HERCULESLOCKHEED-GEORGIA COMPANY
A DIVISION OF LOCKHEED CORPORATION**SERVICE BULLETIN*****MAP, FMS, SAP APPLICABILITY NOTICE***

HERCULESLOCKHEED-GEORGIA COMPANY
A DIVISION OF LOCKHEED CORPORATION**SERVICE BULLETIN****WING - REMOVAL OF DOUBLERS FROM CENTER WING
LOWER SURFACE, CWS 62 TO CWS 68****I. Planning Information****A. Effectivity**

Figure 1. Removal of Doublers from Center Wing Lower Surface,
CWS 62 to CWS 68

REMOVAL OF DOUBLERS FROM CENTER WING LOWER
SURFACE CWS 82 TO CWS 68,
C-130 AIRCRAFT

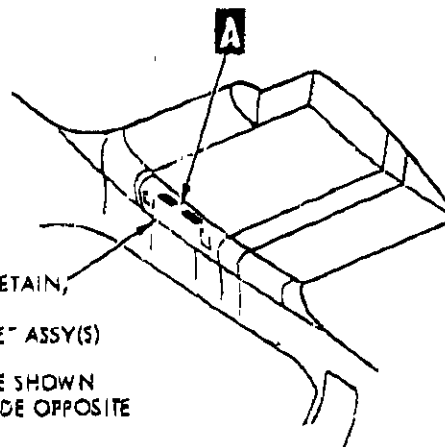
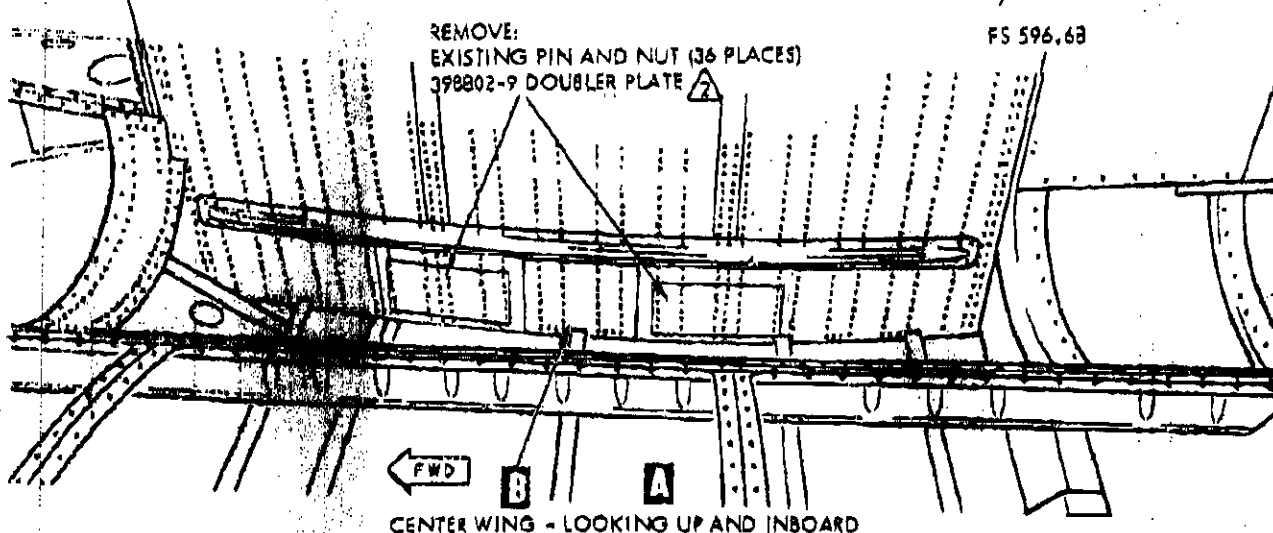
- (1) Two external redundant doublers are presently installed on the center wing lower surface on each side of the aircraft between CWS 62 and CWS 68. These doublers have been determined to be a potential source of stress hard points and have been removed from current production aircraft. Incorporation of this modification will remove a potential source of fatigue from this area of the center wing. This modification will also make redundant one X-ray sampling inspection presently contained in SMP 515-D, Inspection Card SA-24.
- (2) This change is considered as a fatigue improvement modification and may be accomplished at the convenience of the aircraft owner/operator.

This modification consists of removing the four 398802-9 doublers and attaching taper-lok fasteners and replacing with oversize taper-lok fasteners.

- (3) Locate and remove the 398917 and 398919 backing boards from the bottom of the tanks as required to obtain access to taper-lok fasteners attaching the 398802-9 doubler plates to the lower surface of center wing between CWS 62 and CWS 68. (See figure 1, detail B.) Retain backing boards for reinstallation.

- (1) Locate and remove the set of thirty-six taper-lok fasteners installing each 398802-9 doubler plate to wing structure and remove each 398802-9 doubler plate from the wing lower surface. (See figure 1, details A and B.)

- (4) Wet install thirty-six TL210-3-6 pins and TLN1000-3 nuts using PR1422G, Class B-2 sealant, or equivalent, at each doubler location, in accordance with instructions in the Hercules Structural Repair Manual. (See figure 1, detail B.)

- ⚠ WET INSTALL FASTENERS WITH PR1422G, CLASS B-2 SEALANT OR EQUIVALENT.
- ⚠ CLEAN SURFACES OF SEALANT RESIDUE AFTER REMOVAL OF DOUBLERS.
- ⚠ OUTLINE OF REMOVED DOUBLER PLATE SHOWN SHADED FOR REFERENCE.
